**Public Works Committee**

**West End Home Builders' Association | Concerns on Proposed Waste Design Requirements Policy**

**Appendix A** – Drawings Showing Implications of the Proposed  
Waste Design Requirements

**1430 Main St.**

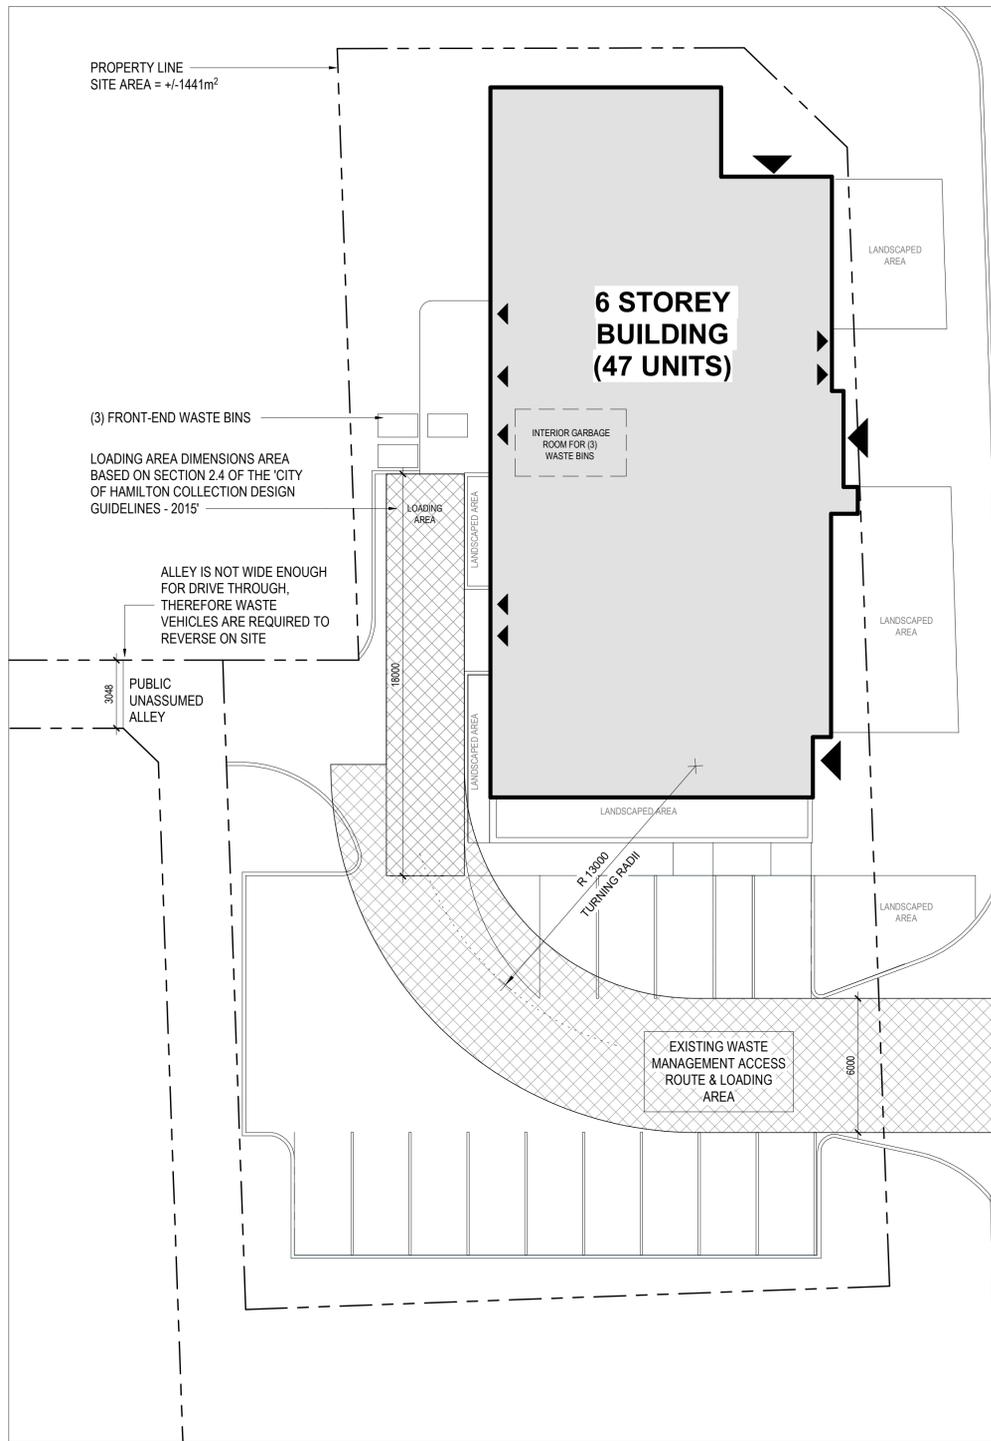
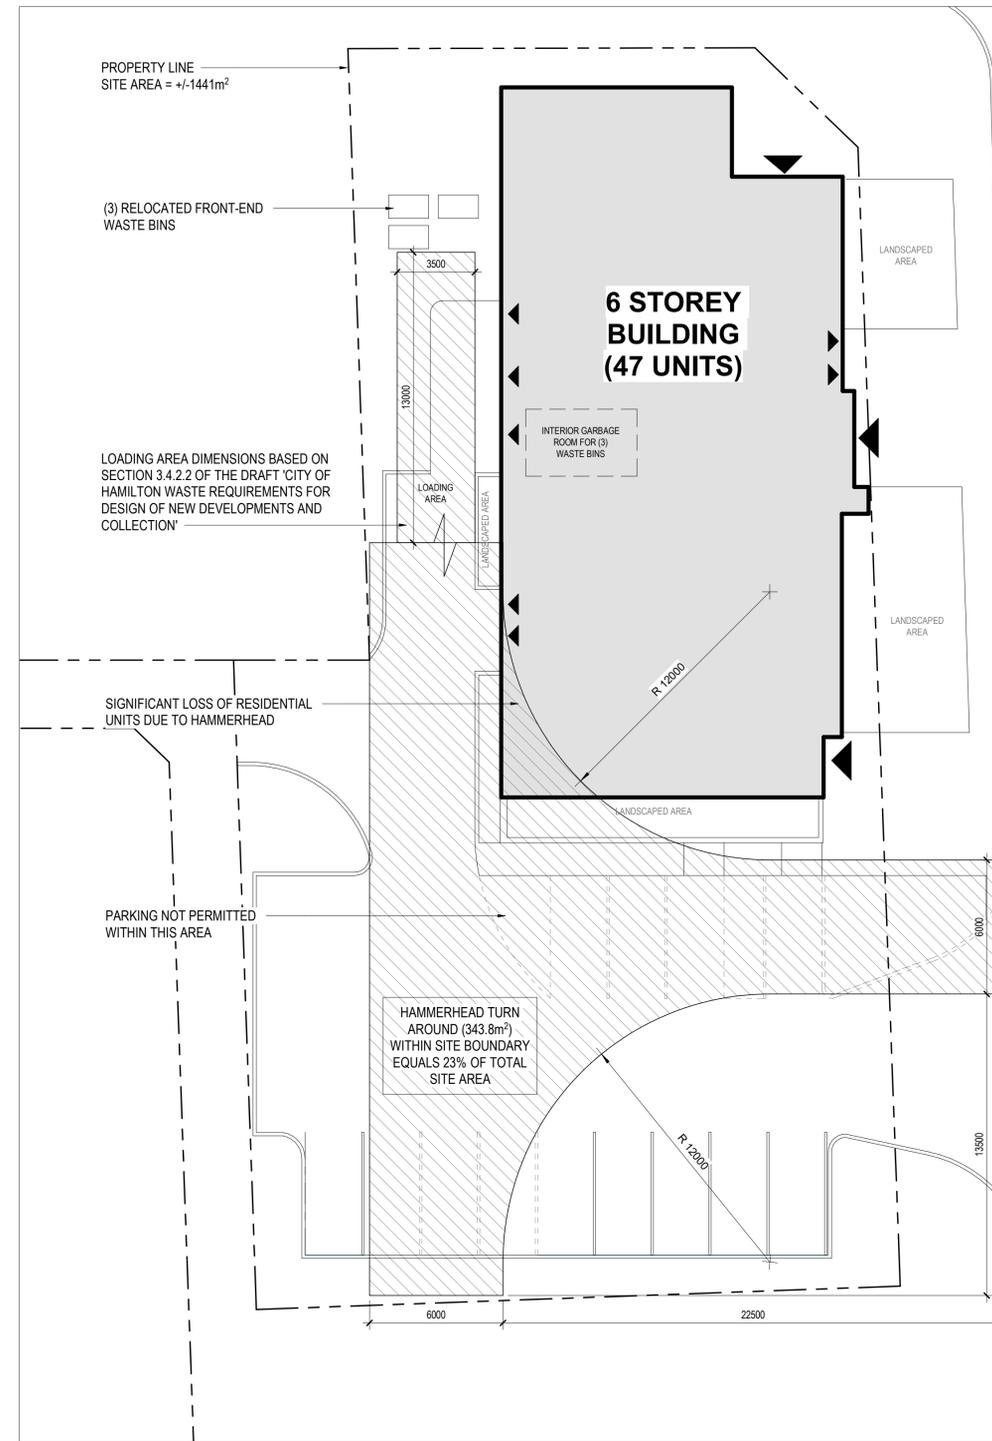
- SIGNIFICANT LOSS OF PARKING DUE TO HAMMERHEAD SPACE REQUIREMENTS (7 SPACES LOST)
- REDUCTION OF BUILDING AREA AND RESIDENTIAL UNITS DUE TO HAMMERHEAD SPACE REQUIREMENTS (MIN. 6 UNITS LOST)
- LOADING AREA IMPEDES EXITING AND EGRESS AT THE REAR OF THE BUILDING
- GOALS FOR INTENSIFICATION WOULD BE REDUCED DUE TO PROPOSED HAMMERHEAD REQUIREMENTS

- 47 UNITS IS REDUCED BY 6 TO 41 UNITS BASED ON BUILDING AREA CLEAR OF HAMMERHEAD**
- 13 PARKING SPACES IS REDUCED TO 7**
- REDUCTION OF PARKING MEANS FURTHER REDUCTION OF UNITS (BASED ON SECTION 5.6 OF BY-LAW 05-200 ASSUMING UNITS AS >50m<sup>2</sup>, AT 0.5 PER UNIT A FURTHER REDUCTION OF 14 UNITS OCCURS)**
- 47 UNITS - 6 UNITS - 14 UNITS = 27 UNITS TOTAL**

**29 HARRIET STREET**

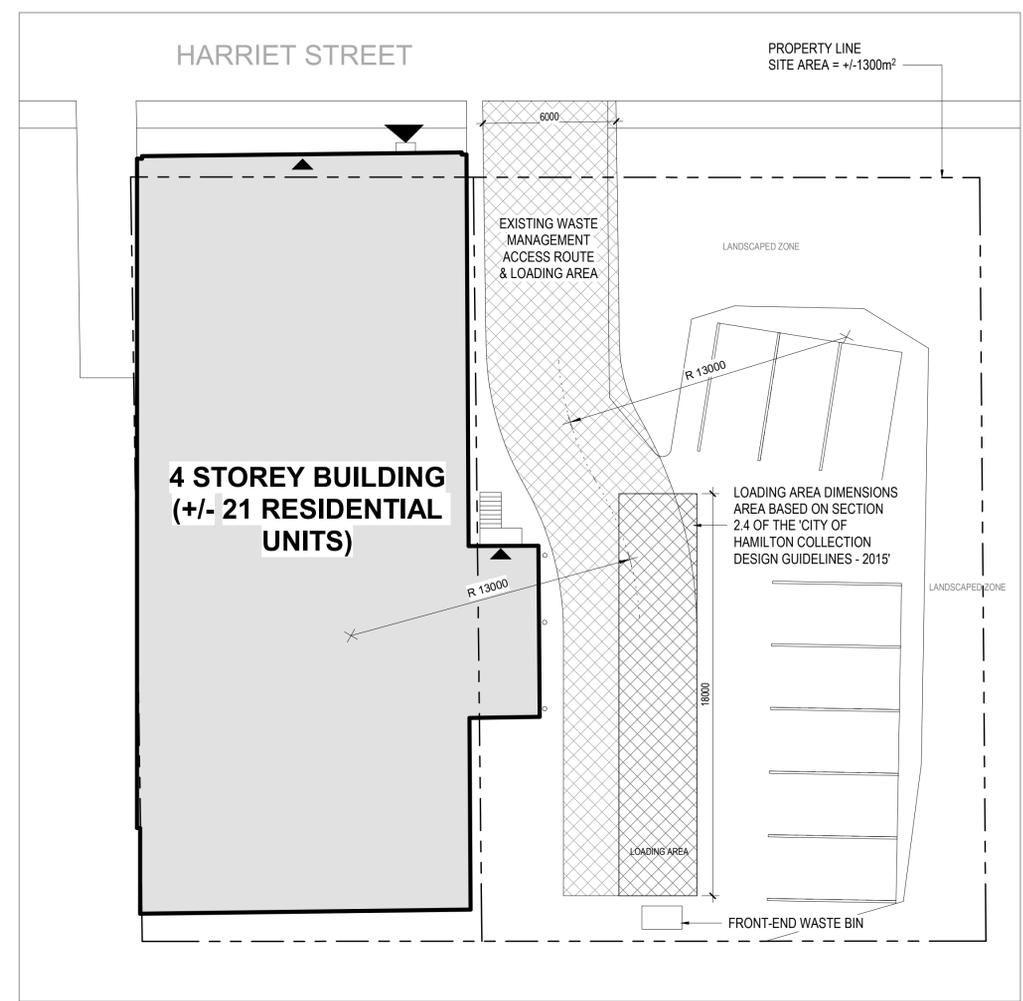
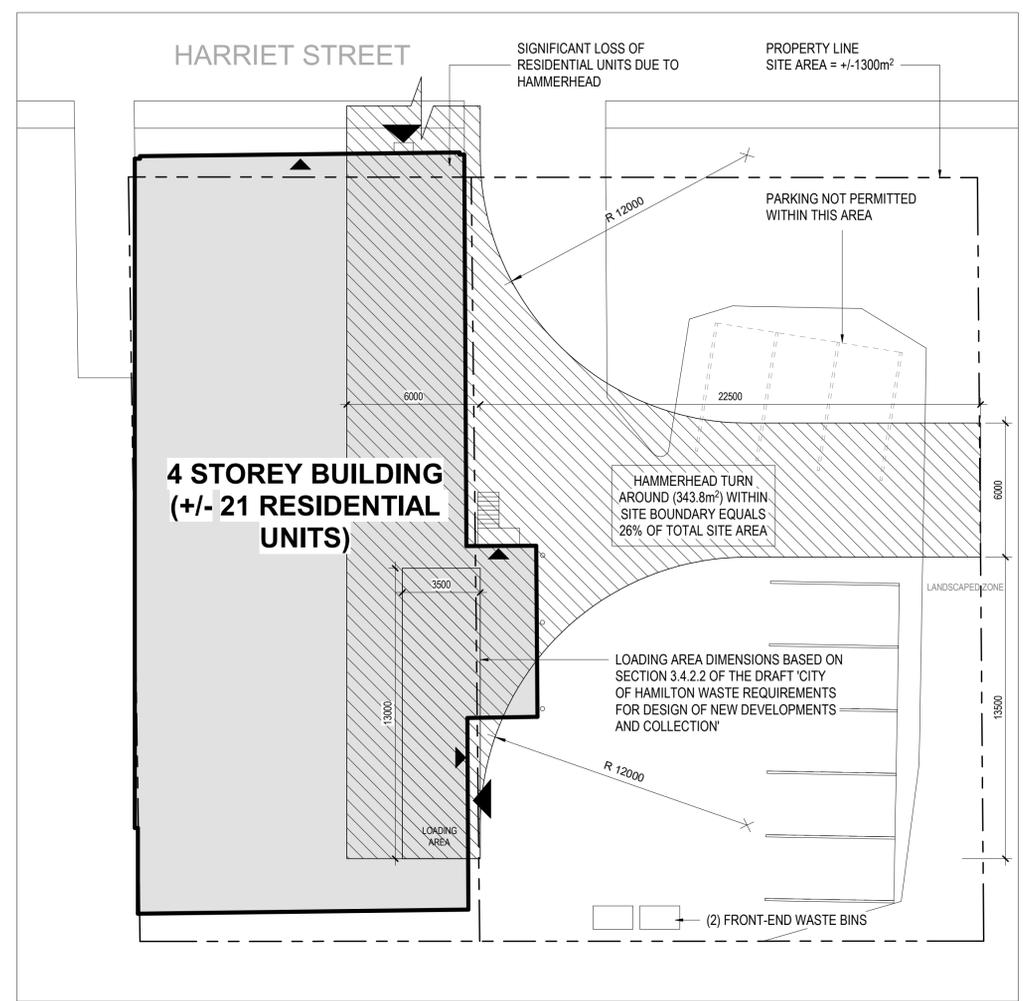
- THE CURRENT PARKING CONSTRAINS WOULD ENCOUNTER SIGNIFICANT LOSS OF PARKING CAPACITY DUE TO HAMMERHEAD SPACE REQUIREMENTS
- REDUCTION OF BUILDING AREA AND UNITS DUE TO HAMMERHEAD SPACE REQUIREMENTS (12 UNITS LOST)
- GOALS FOR INTENSIFICATION WOULD BE REDUCED DUE TO PROPOSED HAMMERHEAD REQUIREMENTS

**POTENTIAL FOR 21 UNITS IS REDUCED TO 9 UNITS BASED ON BUILDING AREA CLEAR OF HAMMERHEAD**

**MAJOR DEMOLITION TO EXISTING BUILDING WOULD BE REQUIRED**

**8 EXISTING PARKING SPACES IS REDUCED TO 5**

92 JOHN ST

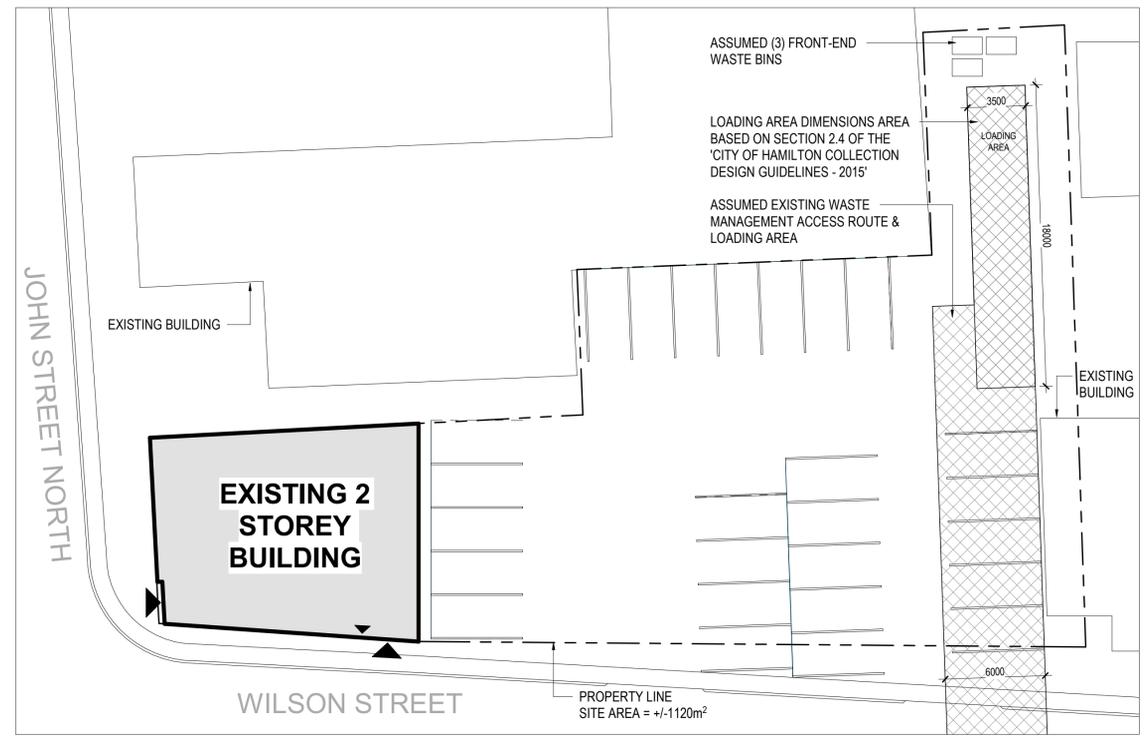
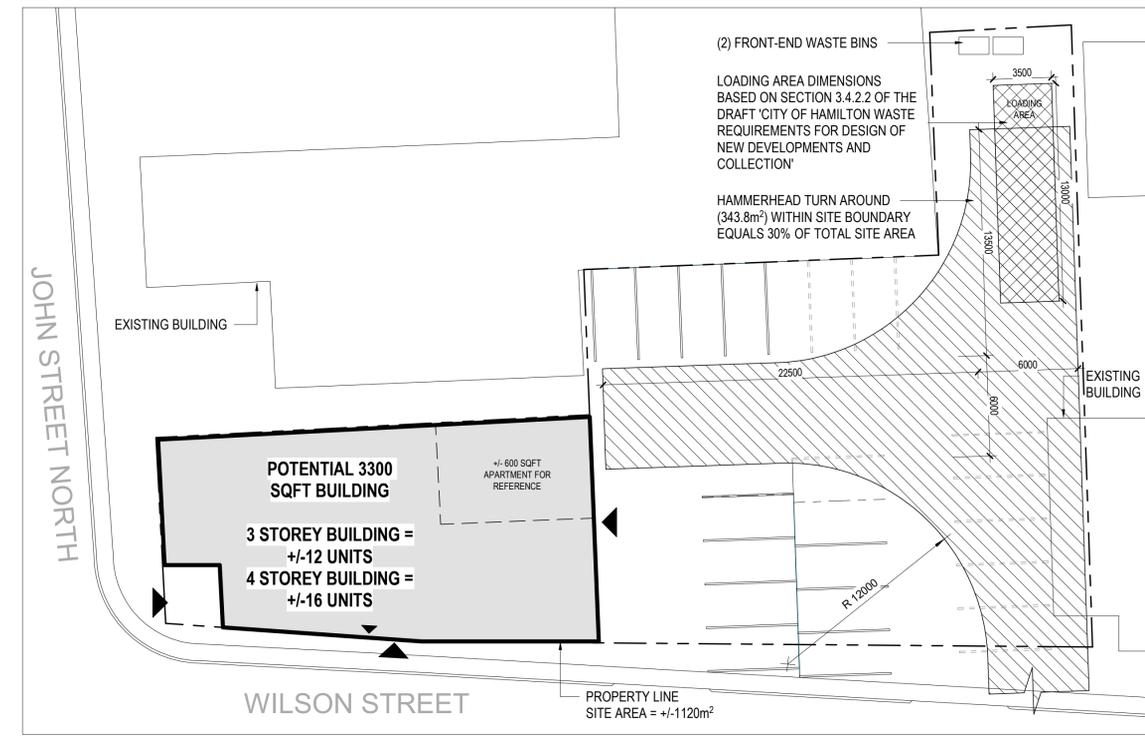
- SIGNIFICANT LOSS OF PARKING DUE TO HAMMERHEAD SPACE REQUIREMENTS AND INCREASED BUILDING FOOTPRINT TO ALIGN WITH GOALS OF INTENSIFICATION (13 SPACES LOST)
- REDUCTION OF BUILDABLE AREA AND RESIDENTIAL UNIT ALLOWANCE DUE TO LIMITED PARKING CAPACITY
- ADDITIONAL STOREYS BASED ON ZONING HEIGHT LIMITS WOULD MEAN THE BUILDING FALLS INTO 'LARGE MULTI-RESIDENTIAL' GARBAGE REQUIREMENTS AND WOULD REQUIRE MORE SPACE FOR GARBAGE
- EXISTING NEIGHBOURING BUILDING WOULD REQUIRE DEMOLITION
- GOALS FOR INTENSIFICATION WOULD BE REDUCED DUE TO PROPOSED HAMMERHEAD REQUIREMENTS

**26 PARKING SPACES IS REDUCED TO 13**

**REDUCTION OF PARKING MEANS REDUCTION OF POTENTIAL UNITS**

**INCREASES TO THE OVERALL BUILDING HEIGHT WOULD ALSO INCREASE THE PARKING AND GARBAGE REQUIREMENTS**

1 SITE PLAN - Isabella (Ottawa)  
A0.07 1:150

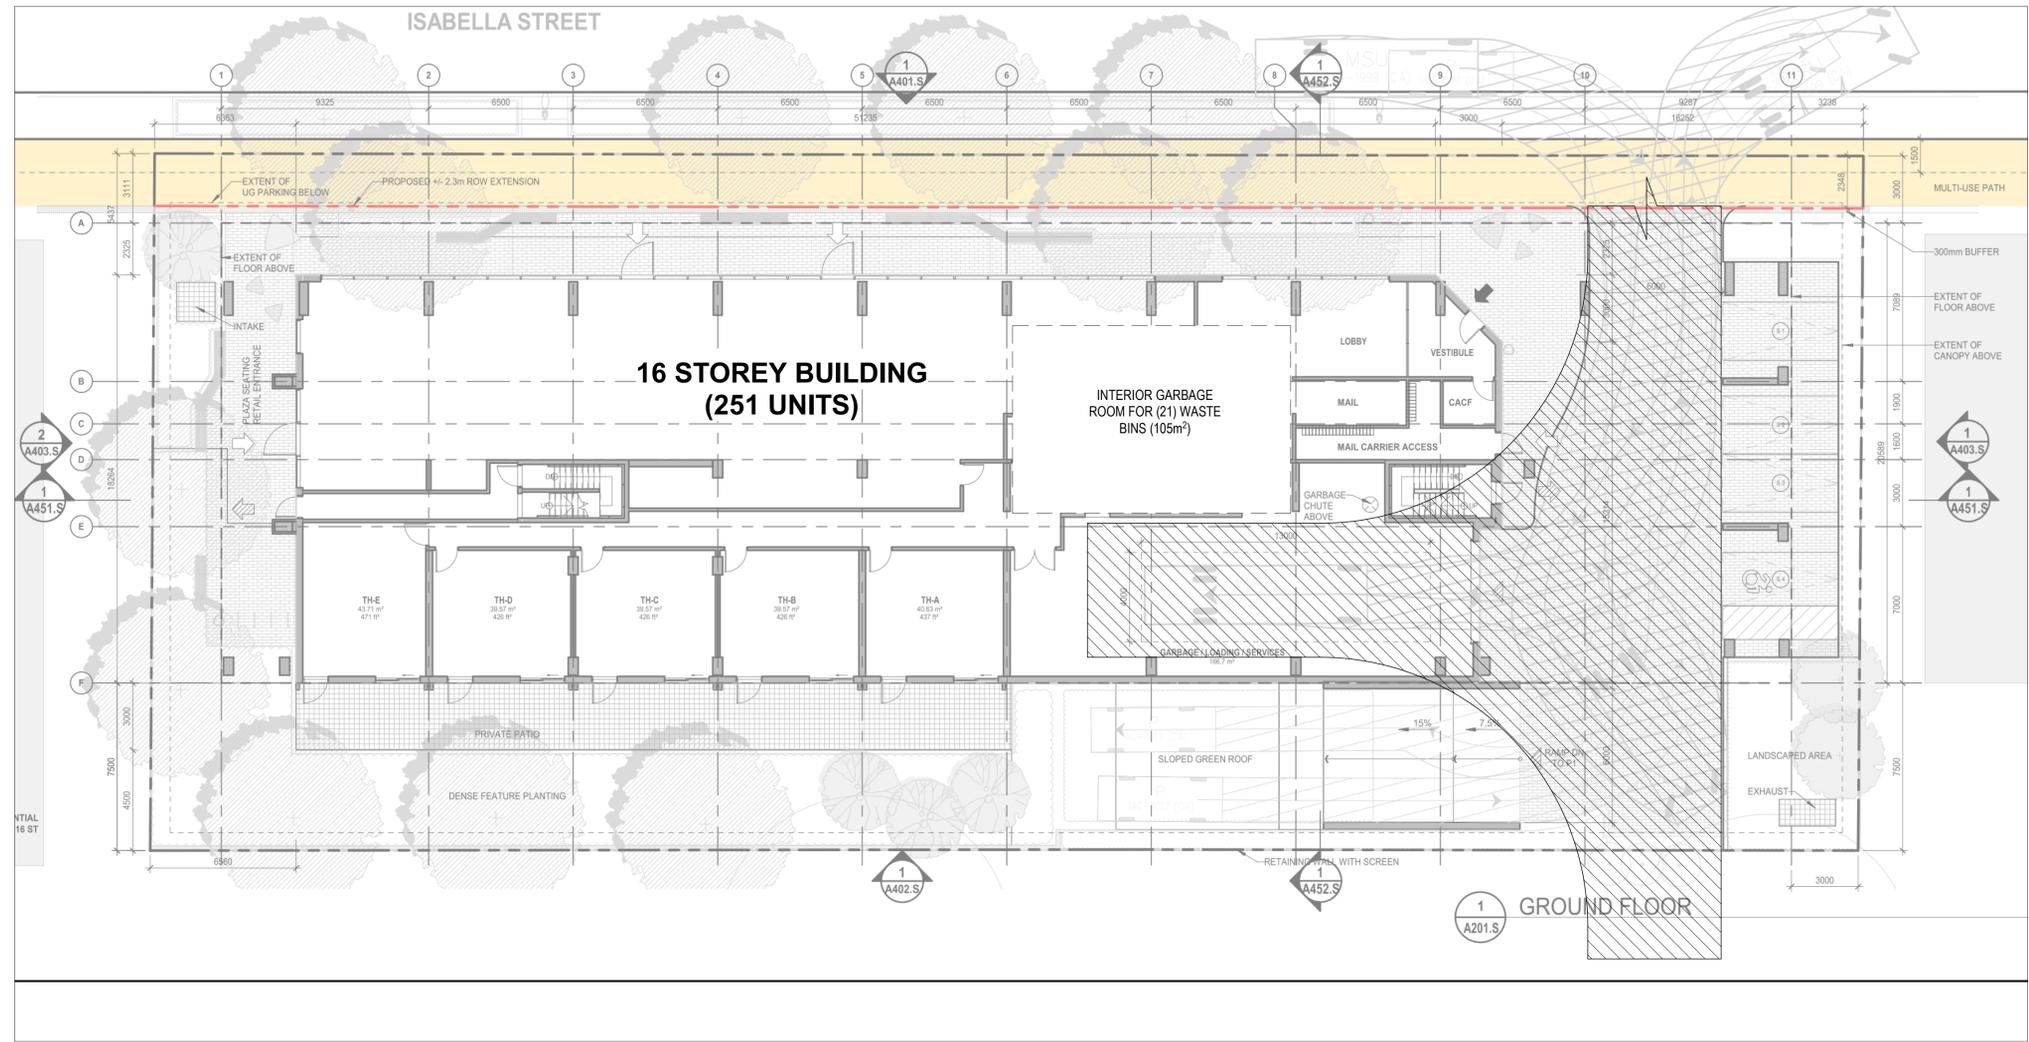
- LOSS OF UNITS AND OVERALL BUILDABLE AREA DUE TO REQUIRED HAMMERHEAD
- LOSS OF UNITS DUE TO SPACE REQUIREMENTS FOR INTERIOR GARBAGE STORAGE
- PROJECT WOULD REQUIRE SIGNIFICANT REDESIGN IF PLANNED FOR THE CITY OF HAMILTON
